This errata sheet provides information about known issues affecting Cyclone® V devices.

Table 1 lists the specific device issues and the affected Cyclone V devices.

**Figure 1. Altera Date Code Marking Format**

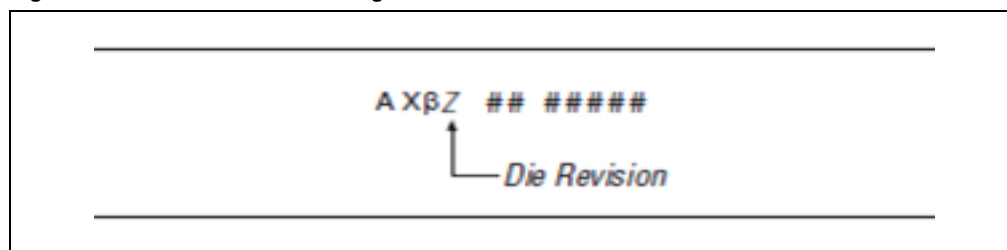
The fix for this issue requires a new die revision. Use the die revision character in the Date Code (printed on the top side of the device) to determine if the device supports CvP. The CvP update can only be used at Gen1 data rates.

CvP is supported if the fourth alphanumeric character from the left ("Z" in Figure 1) is equal to, or later in the alphabet than the letter in the **Revision with Fix** column of Table 4: Device and Die Revisions.
